# COMMUNITY DEVELOPMENT DEPARTMENT REPORT

HEARING DATE: 11/19/2024

FROM: Linda Ritter, Associate Planner  
208-884-5533  
lritter@meridiancity.org

SUBJECT: H-2024-0022  
Skyranch AZ, RZ, PP and MDA

**SKYRANCH SUBDIVISION**  
PRELIMINARY PLAT LANDSCAPE PLAN  
MERIDIAN, ID

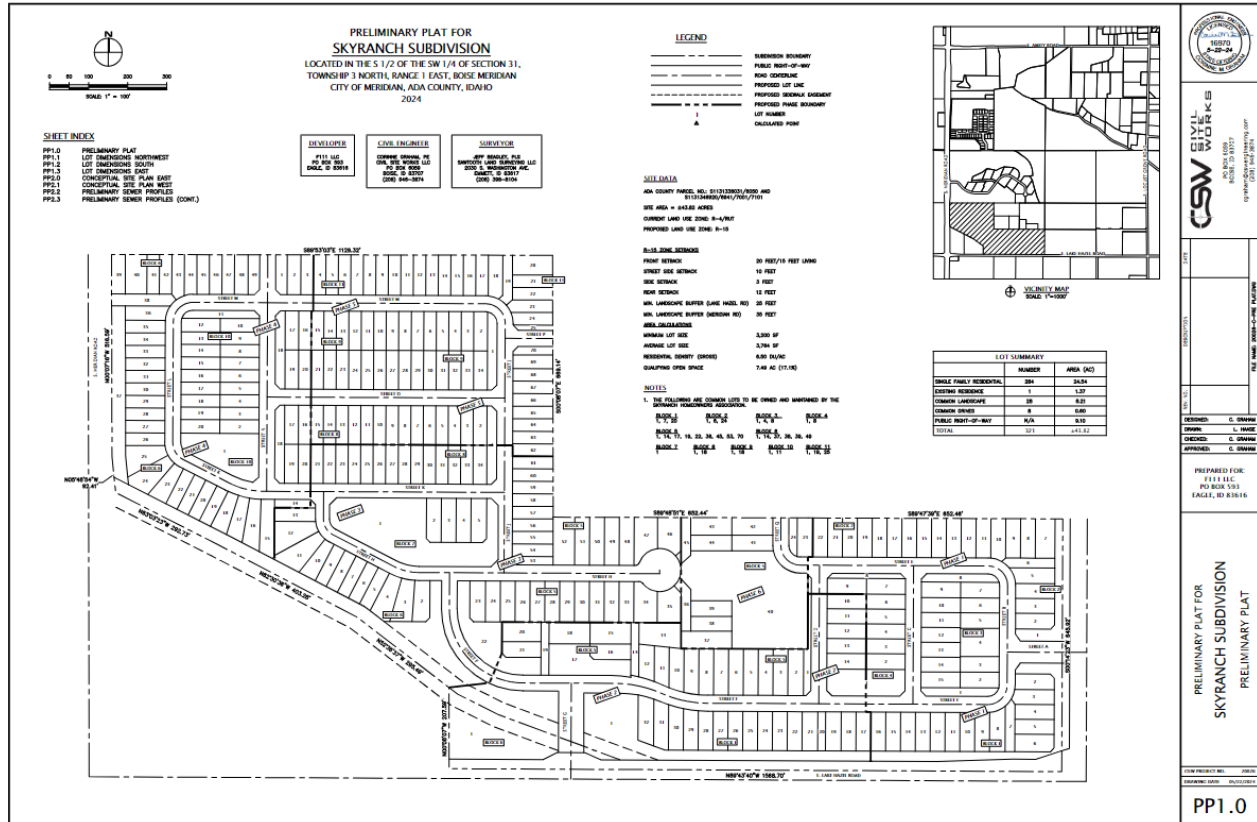
*Although the applicant is proposing a berm, landscaping and fencing around the sports court, staff feels the location would be better if relocated to Lot 1 Block 10 or Lot 1 Block 7 away from the primary entrance to the subdivision which is supported by the Comprehensive Plan policies below.*

*The applicant is proposing parkways along the entrance to Street A, Street F, Street N and Street P of the subdivision.*

### G. Qualified Open Space Exhibit (date: 6/6/2024)

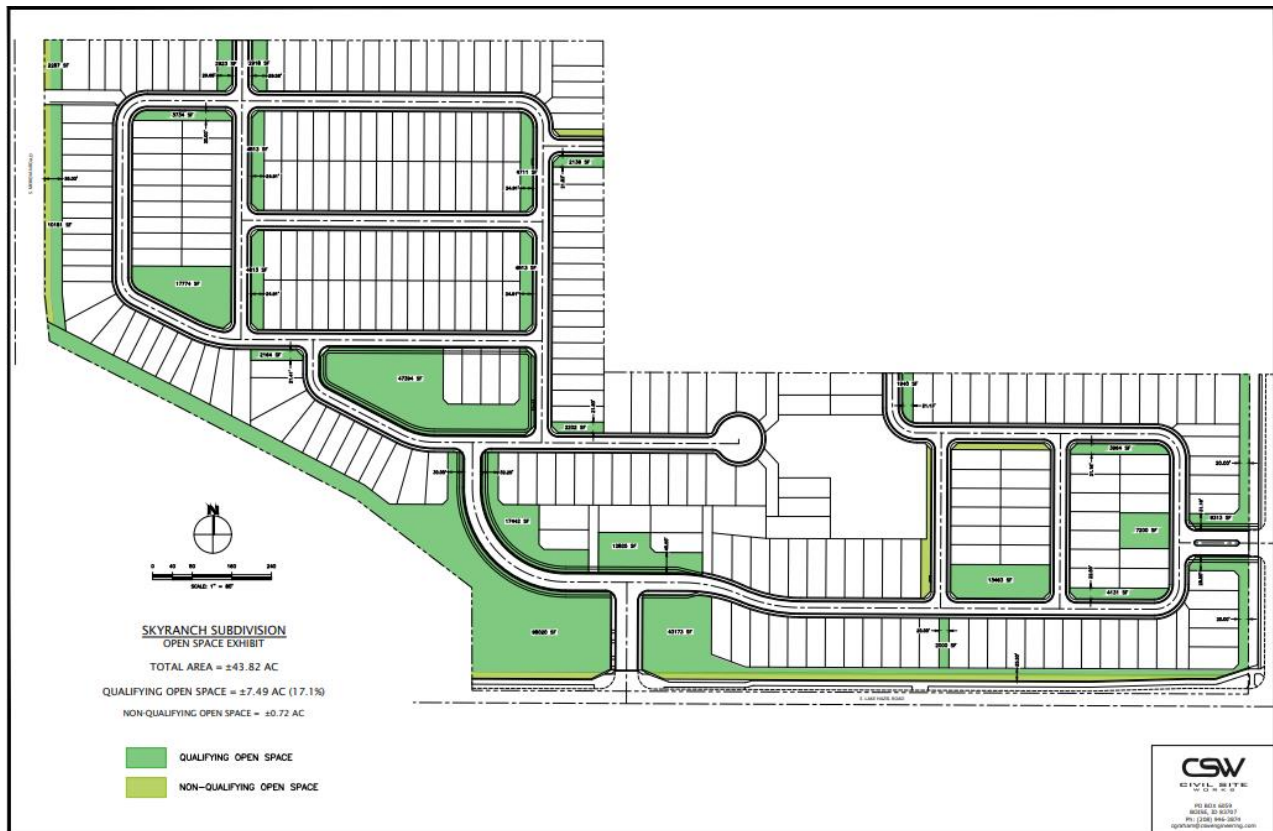
2. **Qualified Open Space & Amenities (Comp Plan 2.02.00, Comp Plan 2.02.01B, UDC 11-3G):**  
*Based on the standards in UDC Table 11-3G-3, a minimum of 15% (or 12.05-acres) of qualified open space is required to be provided within the development. An open space exhibit was submitted as shown in Section VII.F, that depicts 17.1% (or 7.49-acres) of open space that meets the required quality and qualified open space standards. Based on the standards in UDC 11-3G-4A, a minimum of nine (9) amenity points are required to be provided. The amenities proposed are a park with a community pool, play structure, seating benches, climbing dome, swing set; two (2) pickleball courts; dog park with waste station and sitting benches; and pathways. All common open space areas are required to be landscaped with one deciduous shade tree for every 5,000 square feet of area and include a variety of trees, shrubs, lawn or other vegetative groundcover per UDC 11-3G-5B.3.*

I. Common Drive Exhibit (date: 6/6/2024)

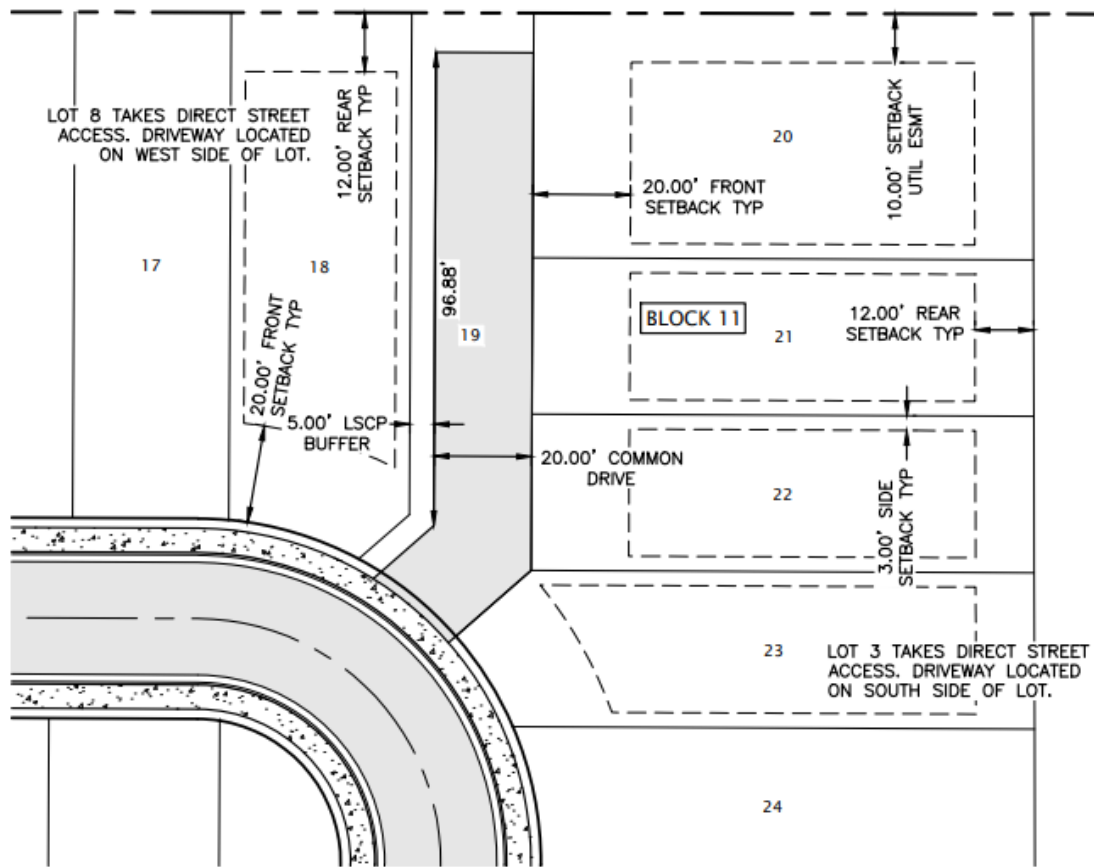
*Eight (8) common driveways are proposed with this subdivision. The applicant has provided common drive exhibits which demonstrate no more than three (3) units are served whereas a maximum of 4 units are allowed. The common driveway meets the minimum width of twenty (20) feet and does not exceed the maximum length of one hundred and fifty (150) feet. Solid fencing adjacent to common driveways is prohibited, unless separated by a minimum five (5) foot wide landscaped buffer.*

*The applicant is proposing six (6) common driveways that meet the dimensional requirements as outlined in the UDC.*
